**MUNICIPAL CORPORATION,**
KARACHI.

Reference No. L. C. P³⁶⁶/40.To Mr. K.T. Tinai, Architect for owner,
Karachi.

With reference to your application dated 7th August 1940
with a plan for the proposed buildings/additions and alterations on plot
No. 79 Survey Sheet No. O.T.4, Old Town. Quarter,

PLAN SHOWING THE PROPOSED BUILDING ON PLOT NO 79 O.T. 4 OLD TOWN QUARTER
SCALE 8 IN TO AN INCH.

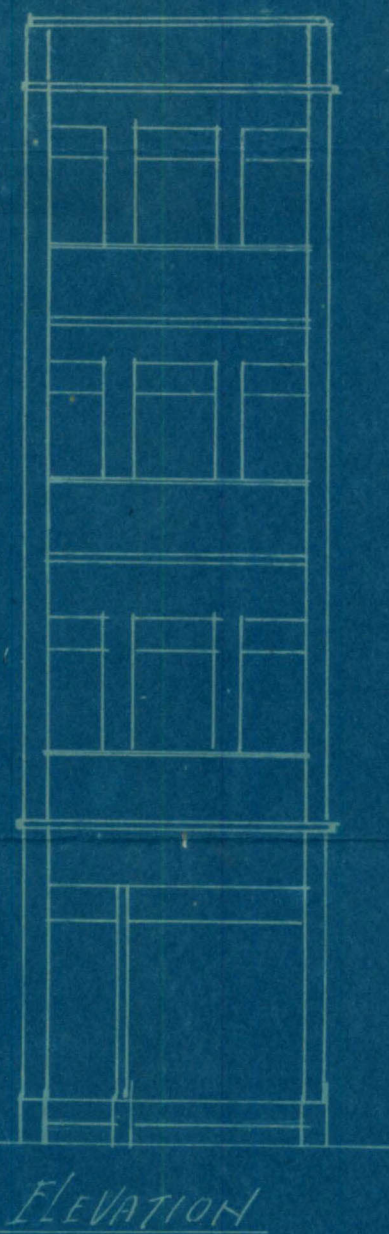
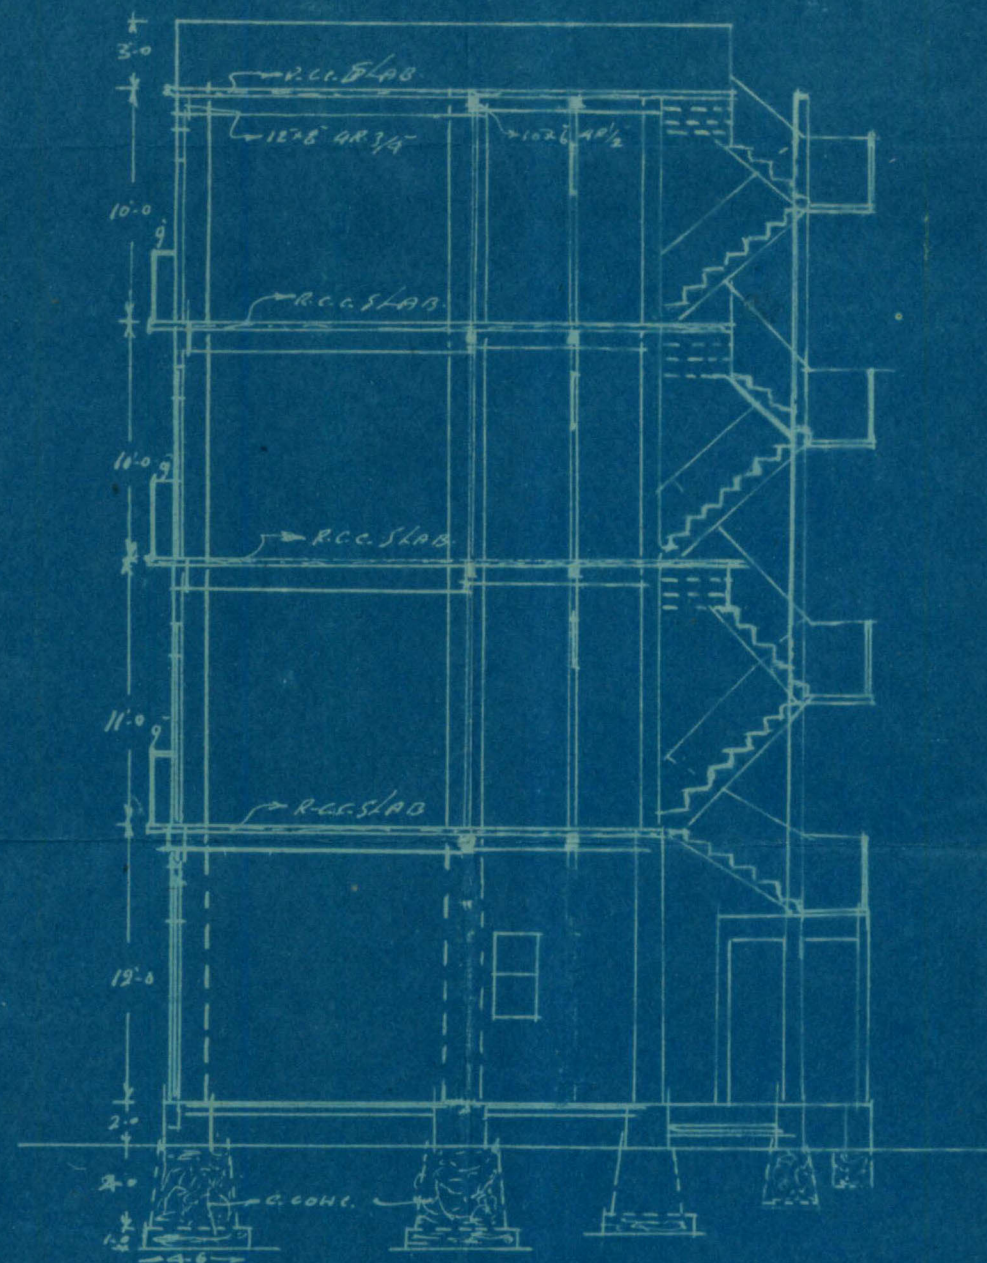
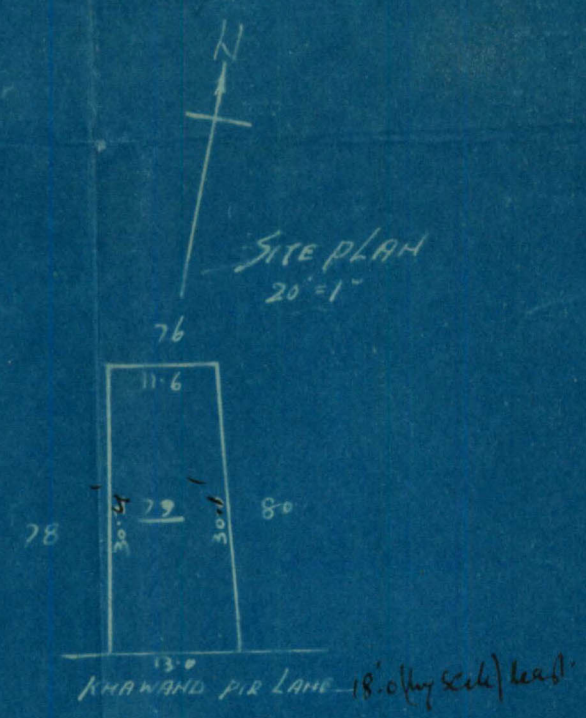
- ✓(1) H.O's objections. Ground floor: Back boundary of "Ver" not clear.
- ✓(2) No kitchens provided.
- ✓(3) Space behind the stairs - purpose not stated.
A.E's objections.
- ✓(4) W.C. adjoining living room is against rules.
- ✓(5) Better drawings may please be submitted as blue-print is not legible.
- ✓(6) Dimensions of the U.G. tank should be given and it should be at least 5' away from the manholes and drainage lines. Also it should be 2' away from adjoining owners' wall.
- ✓(7) O.H. tank should be shown.
- ✓(8) I.T. should be provided within the owners' limit and V.P. should be provided to it.

- ✓(9) Site measurements be corrected.
- ✓(10) Street width be given.

- ✓(11) Plans must be signed by the owners.
- ✓(12) W.C. behind staircase cannot be allowed, also one adjoining the room is against rules.
- ✓(13) Street width be given and height regulated accordingly.
- ✓(14) Passage will be too narrow, due to pillars etc.
- ✓(15) New drawings require to be submitted as the one's sent ~~are~~ cannot be read.

The plans are returned herewith rejected.

*1. Side measurements be corrected.**2. Street width be given**9/8/uo*
Head Draftman.*80-1418*
LAND SURVEYOR.*15/8*
13.8

1. W.C. adjoining living room is against rules.
2. Better drawings may please be submitted as blue-print is not legible.
3. Dimensions of the U.G. tank should be given and it should be at least 5' away from the manholes & drainage lines. Also

SIGNATURE OF THE.....
it should be 2' away from adjoining owner's wall.

4. O.H. tank should be shown.
5. I.T. ~~etc~~ should be provided within the owners limit and V.P. should be provided to it.

Ground floor: Back boundary of
"Ver" not clear.

no Kitchens provided.

Space behind the stairs -
purpose not stated.
